PUBLIC COMMENTS

WOBA undertook a detailed review of TxDOT's 2/09 Drainage Mitigation Study for the I-10 Project as well as the 2/10 detention pond renditions and the road construction plan sets. In view of the following questions and comments, it is our hope that TxDOT will revisit their drainage study and make modifications to their plans as they relate to detention and mitigation of flows on lower WOB.

RESPONSE TO PUBLIC COMMENTS

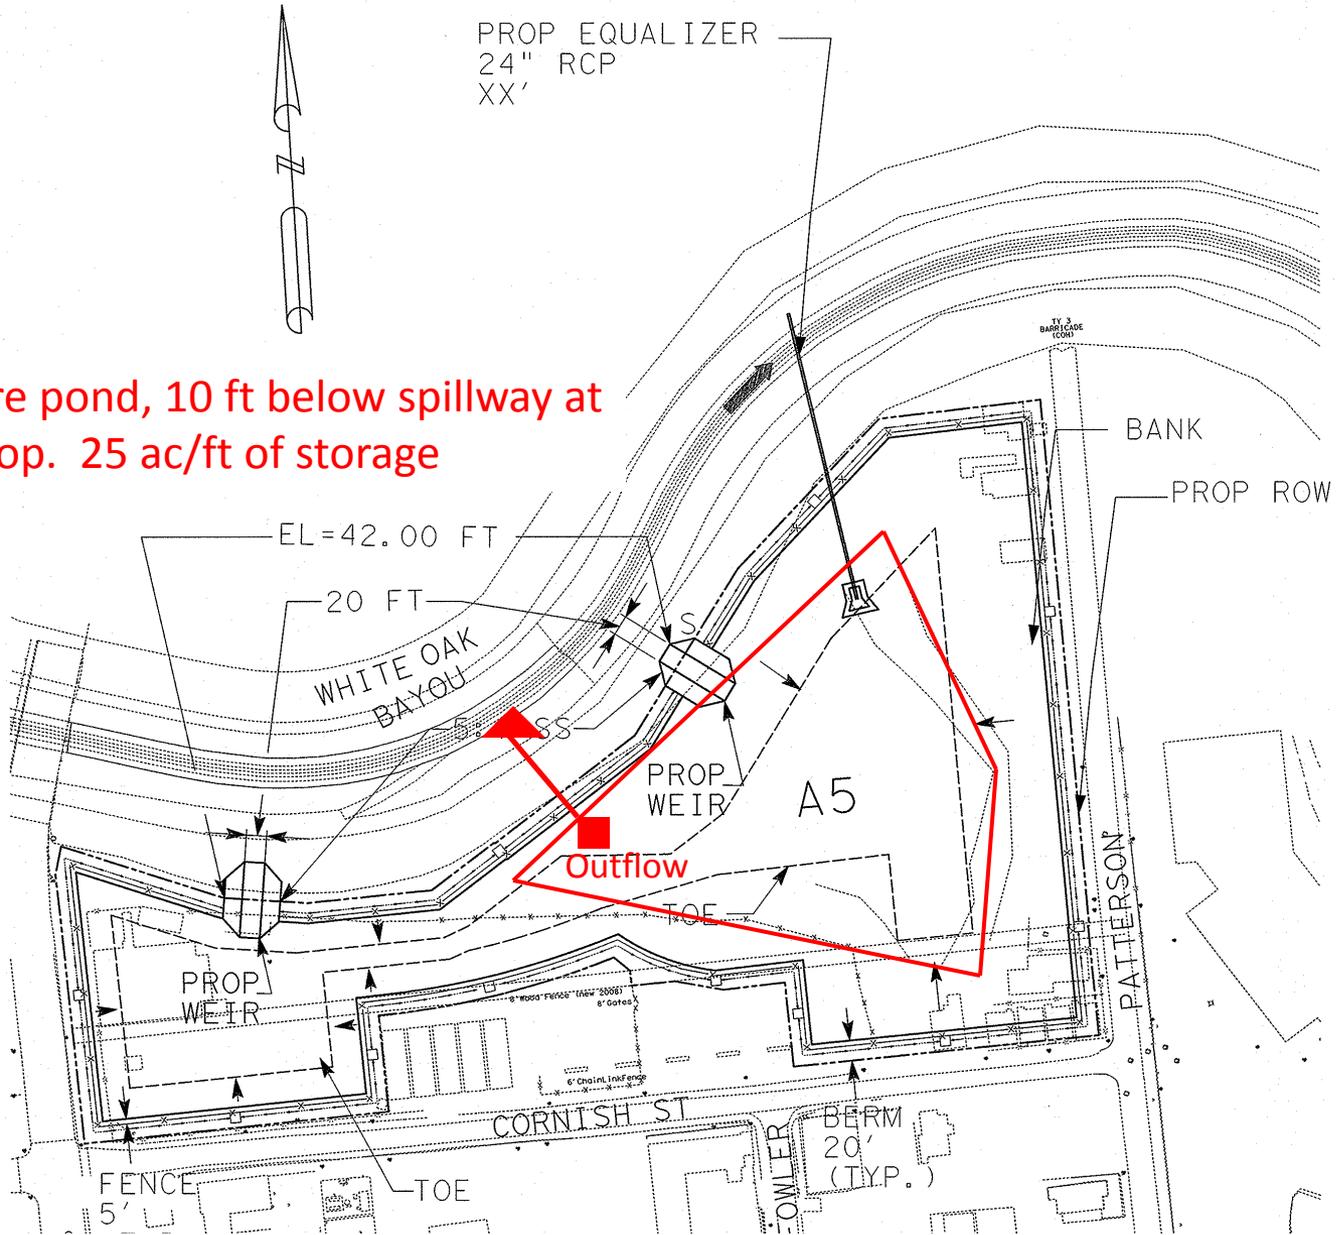
Yale Street at I-10 and the nearby Yale bayou bridge are located at 42' which is 2-7' below the BFE at this location. The lower chord of the planned eastbound bayou feeder road bridge at this location is at 3-7', again several feet below the BFE. We encourage TxDOT, the COH and Harris County Flood Control District (HCFCD) to coordinate and address flood risks at this location.

If TxDOT proceeds as planned with the eastbound feeder connection to Yale, it will make it extremely difficult and expensive to raise the grade at Yale and/or replace the 80 year old Yale bayou bridge at a higher elevation in the future. Additionally, TxDOT's feeder roads and bridges will pull increased traffic into this high risk flood area. This is a public safety concern as noted earlier in this letter.

Existing Detention Inside Proposed A5 Site

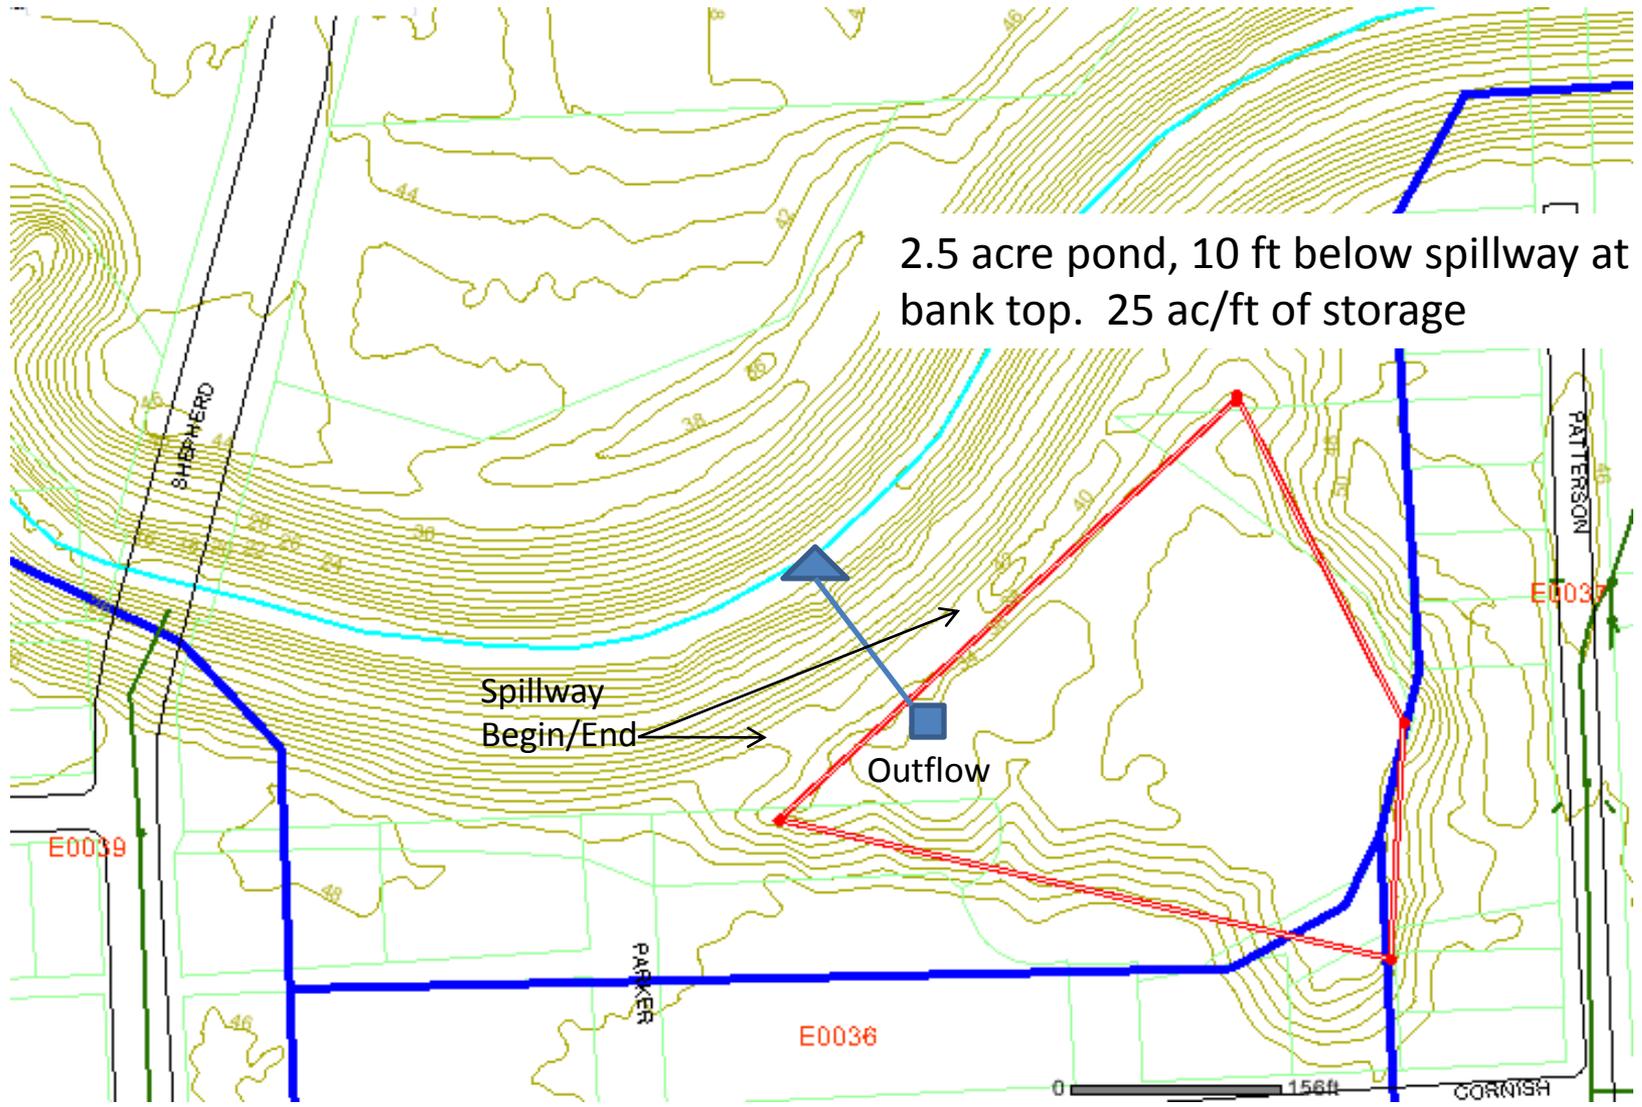
WOBA asks TxDOT to explain in detail how the capacities of the proposed detention pond facilities were calculated. WOBA is concerned that TxDOT may be unknowingly claiming existing storm water storage capacity as their own at site A-5. Please see attached document: I-10 A-5 Existing Detention

2.5 acre pond, 10 ft below spillway at bank top. 25 ac/ft of storage

**TxDOT
A5**

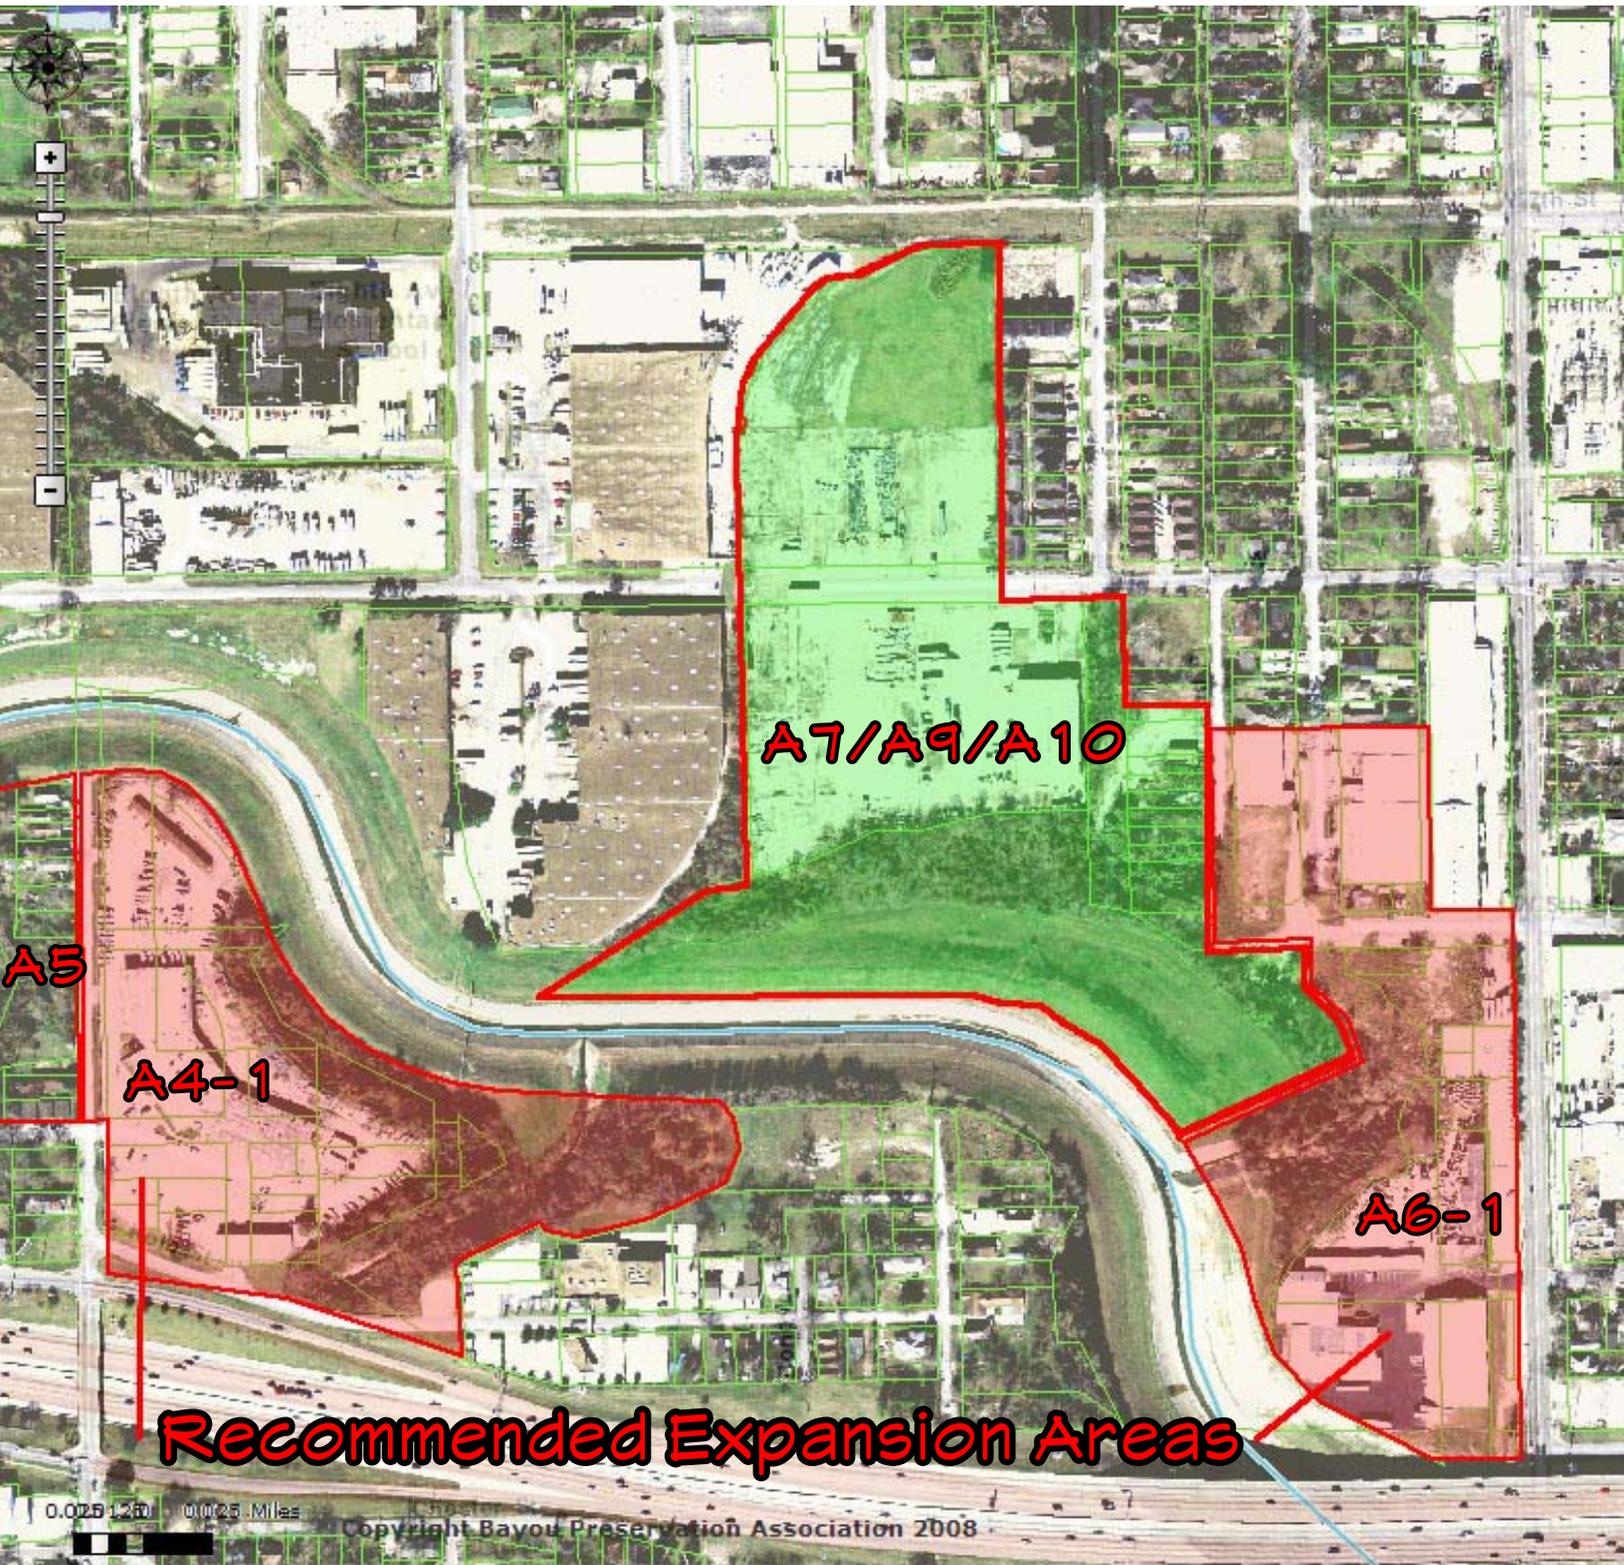
- a. Design A5 basin as if the A4-1 basin will be built at a future date.
- b. Remove west inflow weir to save cost and reduce amount of concrete visible from North Shepherd. This small basin will be adequately served by one weir.
